CITY OF WICHITA

Re: **BZA2002-00036: Zoning Adjustment to reduce the compatibility setback for a dumpster along the west property line from 20 feet to 7 feet.**

VIA CHRISTI
OFFICE ADDITION - SHELL PACKAGE
1515 SOUTH CLIFTON
WICHITA, KS

BZA 2002-00036

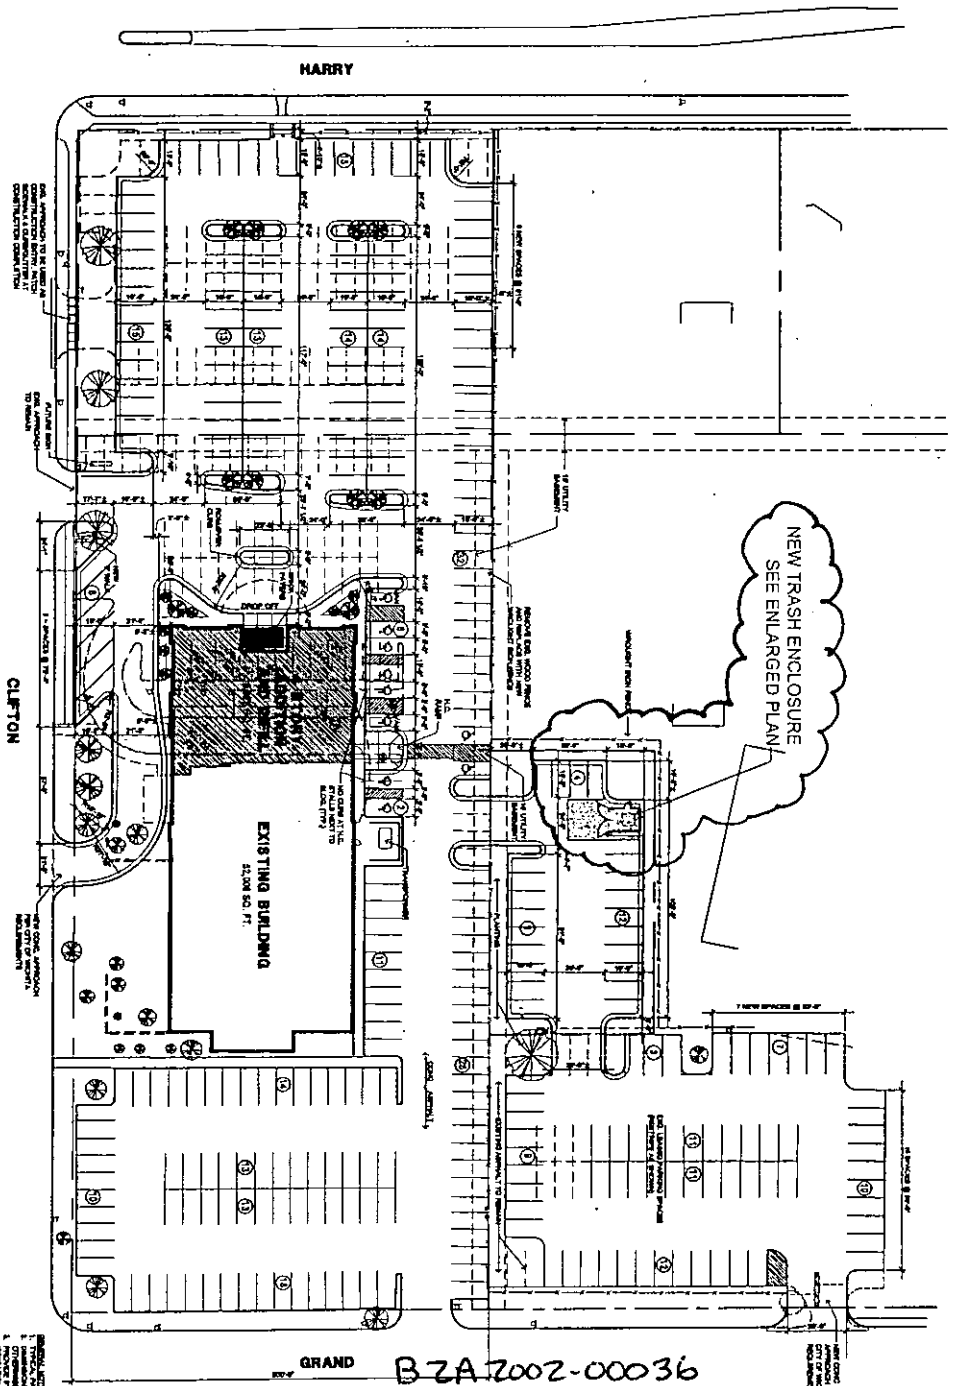
We have reviewed your request for a Zoning Adjustment to reduce the compatibility setback for a dumpster along the west property line from 20 feet to 7 feet. From reviewing your application, we understand that you desire to place the trash dumpster in the western-portion of the parking lot so that it is located away from the building and away from reserved physician parking areas. Since the property west of the subject property is zoned "TF-3" Two-Family Residential, Sec. IV-C.7.b. of the Unified Zoning Code requires a 20-foot compatibility setback for the dumpster along the west property line. Since the property to the west is not developed with low-density residential uses but with an institutional use, you requested a Zoning Adjustment to reduce the compatibility setback for a dumpster along the west property line from 20 feet to 7 feet.

2) Impact on existing uses in surrounding areas: There should be no negative impact on the existing uses in surrounding areas as a result of the reduction of the compatibility setback, as the dumpster will be screened and will be located adjacent to an open space for a church and school rather than a residential structure.

3) Compatibility with existing or permitted uses on abutting sites: The compatibility setbacks for dumpsters are intended to prevent dumpsters from being located in close proximity to low-density residential structures. A 13-foot reduction of the compatibility setback for a screened trash dumpster will not make the dumpster incompatible with an open space for a church and school.

Our signatures below indicate that a Zoning Adjustment to reduce the compatibility setback for a dumpster along the west property line from 20 feet to 7 feet for the aforementioned property is hereby granted, subject to the following conditions:

1) The site shall be developed in general conformance with the approved site plan.

2) The setback reduction shall apply only to the "Trash Enclosure" as illustrated on the approved site plan. All other structures or additions on the subject property shall conform to the compatibility setbacks permitted by the Unified Zoning Code unless a separate Zoning Adjustment is granted.
